DEPARTMENT OF PLANNING AND ZONING

TO: Potomac Yard Design Advisory Committee

SUBJECT: Potomac Yard Landbays G&H Discussion

Exhibit MU-1

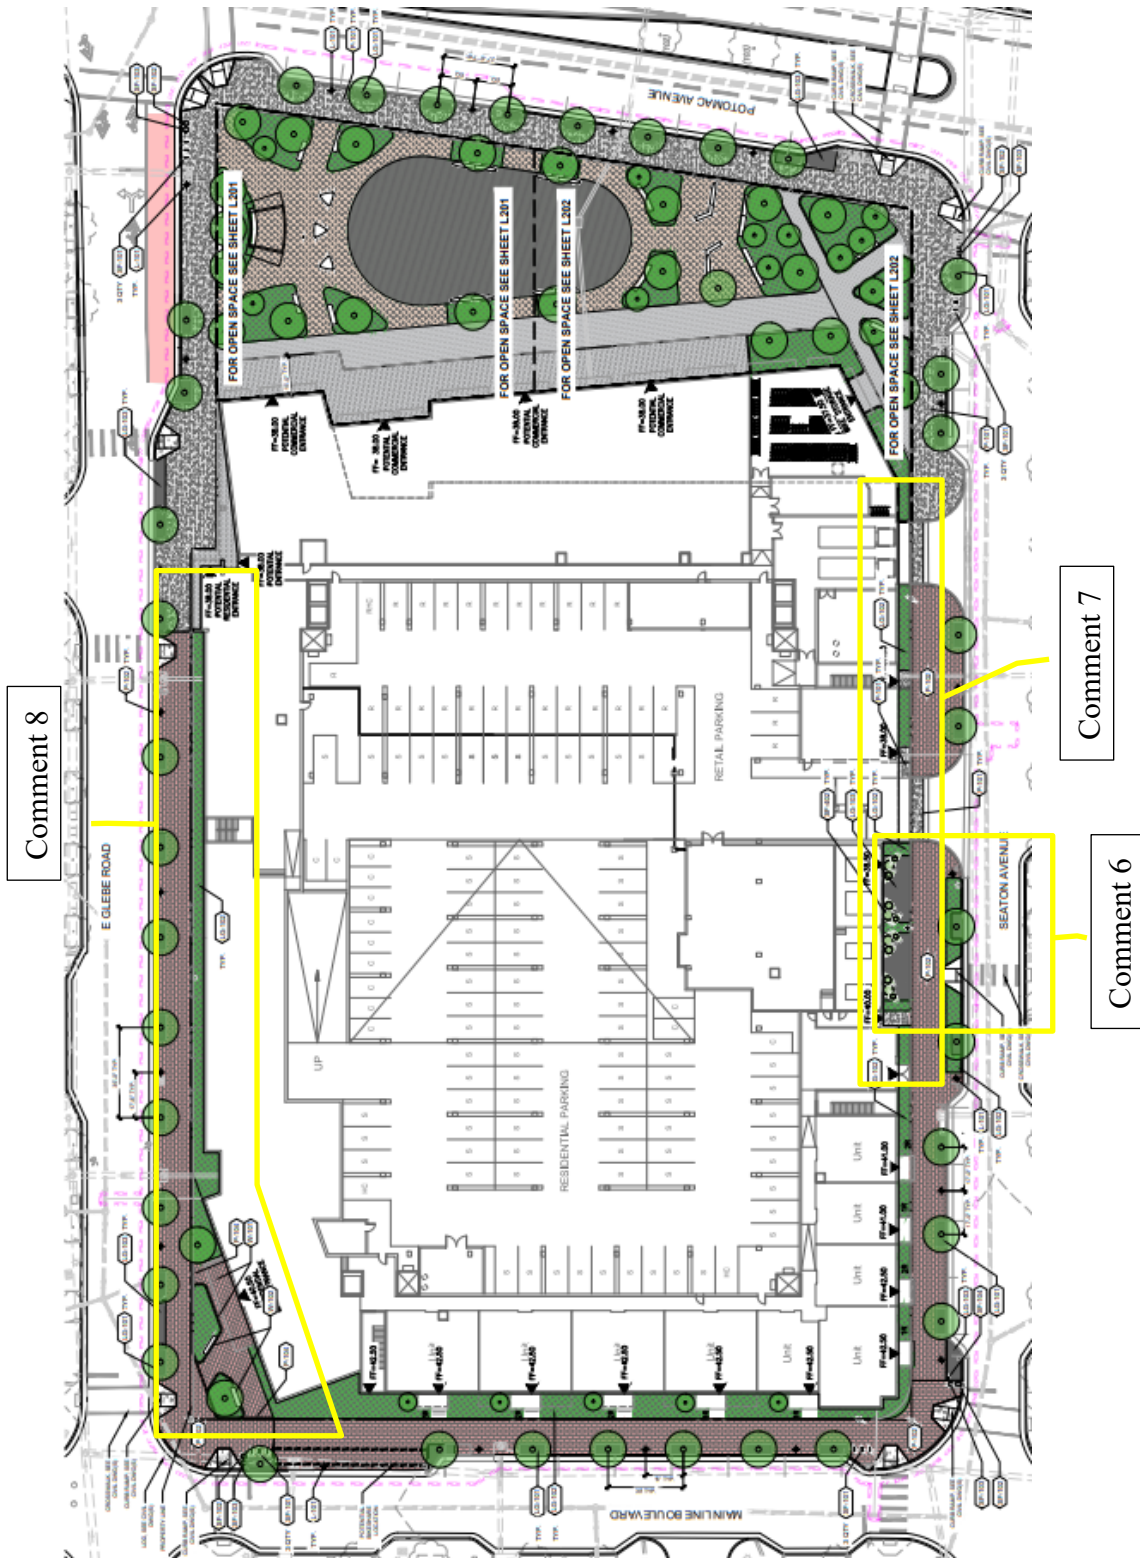
1. Shifted the proposed commercial space further north towards Glebe Road, thereby activating the main street between Route 1 and the Metro Station South entry. This shift will better relate to the vacant commercial space directly across the street in the NIB building. (Exhibit MU-1)
2. Shifted the east facing lobby entry to the multi-unit residential in a way that results in a more interesting and “happen stance” impact on the Glebe Road façade. (Exhibit MU-1)
3. Provided updated architectural elevations show the use of lighter colors and a massing of elements that assist in breaking up the overall building mass. (Exhibit MU-2)
4. Enhanced the small plaza space at the lobby entry at Glebe Road and Main Line Boulevard. (Exhibits MU-1 and MU-2)
5. Provided a dedicated location for a bikeshare station on Main Line Boulevard. (Exhibit MU-1)

6. Explore ways to further improve the relationship between the southern pedestrian crosswalk across Seaton Avenue and the proposed building and ground plane. Explore how this space can be further activated as well as consider enhancing the mid-block pedestrian crossing by creating a larger landing area. (Exhibit MU-1)
7. Further explore ways to activate the southern façade and adjoining walkway. Consider different murals/art or historical elements that draw people west towards the town center

open space. Any art or railway historical theme could be emphasized at the point where the mid-block pedestrian crosswalk meets the building. (Exhibit MU-1 and MU-2)

8. Explore ways to further activate north façade of the building and the northwest corner plaza, both areas are on a major walking route to and from the Metro Station. (Exhibit MU-1 and MU-3)

Exhibit AFF-1: Main Entry

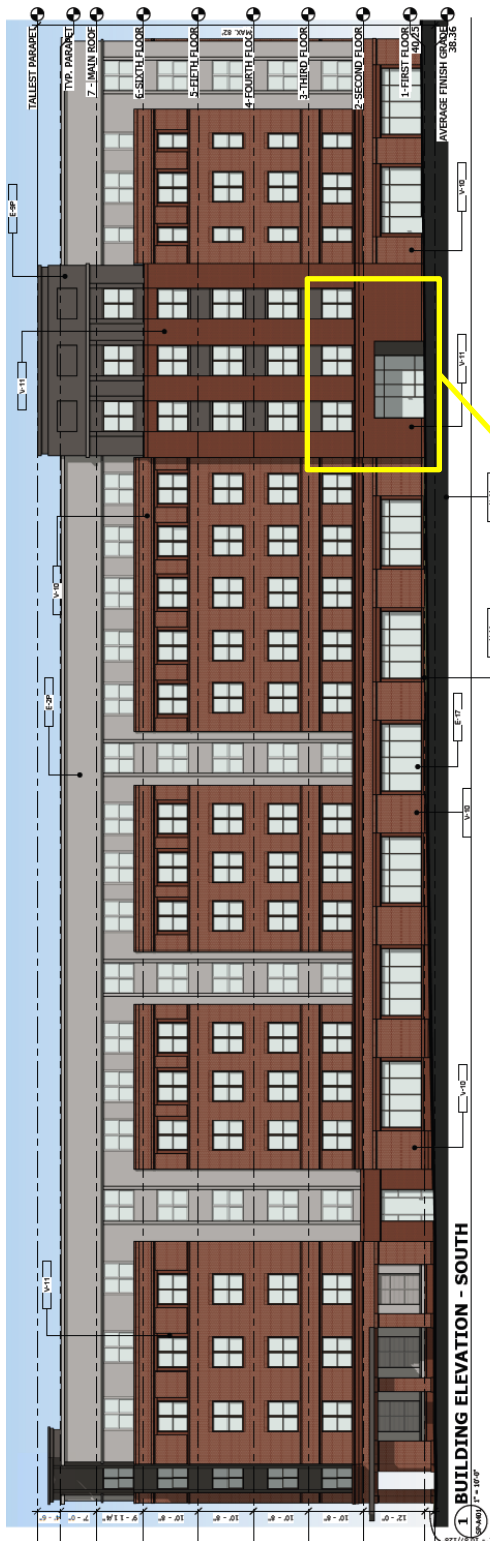
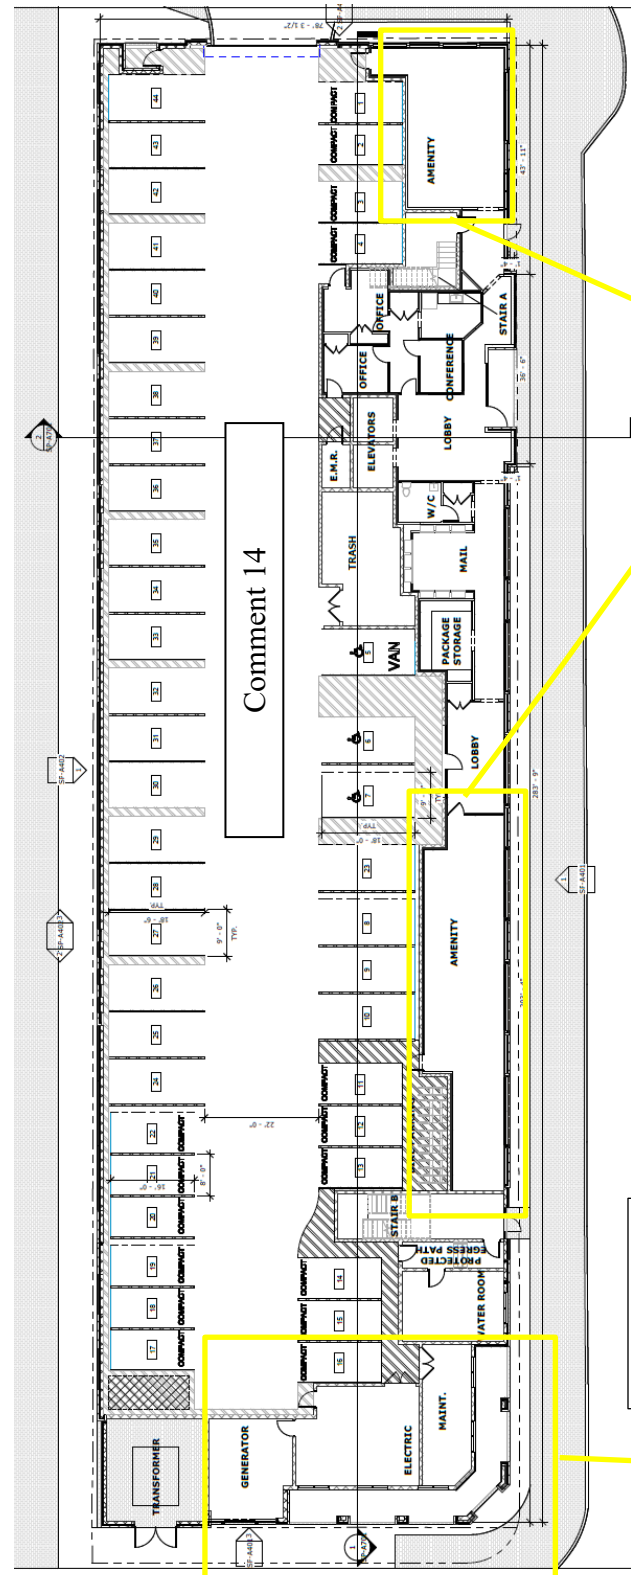
9. Enhance design details to emphasize main entry on Glebe. (Exhibit AFF-1)
10. Have enlarged amenity space at the southeast corner of the first floor. (Exhibit AFF-2)
11. Corner design enhancement with subtle tower feature creating a stronger design presence at this corner. (Exhibit AFF-3)

12. Explore ways to make the main lobby entry more prominent on the first floor. (Exhibit AFF-1)
13. Which street corner should weigh more heavily in activating the first floor, southwest corner at Route 1 or the southeast corner at Mainline Boulevard or both. (Exhibit AFF-2)
14. How do we balance the need for parking space with the desire to activate the first floor? (Exhibit AFF-2)
15. Does the colonnade at the southwest corner of the building detract or add the building? (Exhibit AFF-3)
16. Does the colonnade communicate entry to the building? (Exhibit AFF-3)
17. North elevation, first floor. Consider another pattern to break up the floor that provides a more regular pattern. (Exhibit AFF-4)
18. Explore a more orderly pattern of blind or ventilated openings on the first-floor north façade, perhaps using the Glebe Road first floor façade as a cue. (Exhibit AFF-4)
